APPLICATION NO.	FILING DATE	FIRST NAMED INVENTOR	ATTORNEY DOCKET NO.	CONFIRMATION NO.
10/724,375	11/26/2003	Zhi-Min Choo	2060-3-85	9666

Office Action Summary	Application No. 10/724,375	Applicant(s) CHOO, ZHI-MIN	
	Examiner Richard M. Bemben	Art Unit 2622

Modified Figure 5 from applicant's specification

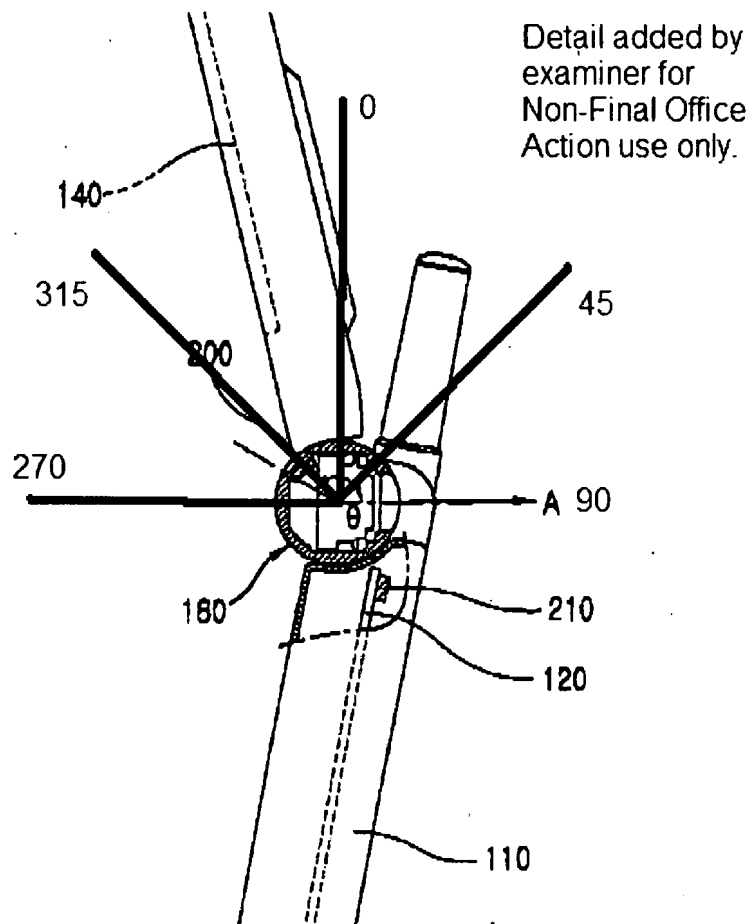
Applicant's specification (US 2004/0110541) requires photographic apparatus 160 to have a range of motion of 180° ([0030]). Referring to paragraphs [0034] & [0035] and Figures 5 & 6, the limits of the photographic apparatus' rotation are unclear. For instance, if direction "A" in Figure 5 is 90° and the photographic apparatus can rotate 180° , in order to be able to capture images of both the user and the scene at 90° , the photographic apparatus must only rotate between 270° and 90° , through 0° (which is the 180° rotation required). This is shown below:

According to [0034], if the photographic apparatus is rotated from 330° to 90° , the rotation angle is less than or equal to 150° . First, rotation between 330° to 90° is less than or equal to 120° . Second, it appears that the 150° rotation ends at direction "A" or 90° . However, [0035] appears to require the photographic apparatus to rotate at an angle exceeding 150° (it is unclear where the 150° starts and ends, it is assumed by the examiner that the 150° ends at 90° according to Fig. 5). As described above, if the photographic apparatus can only

rotate between 270° and 90° through 0°, then the rotation angle cannot exceed 150° (if 150° ends at 90°).

Appropriate clarification and/or correction is required.
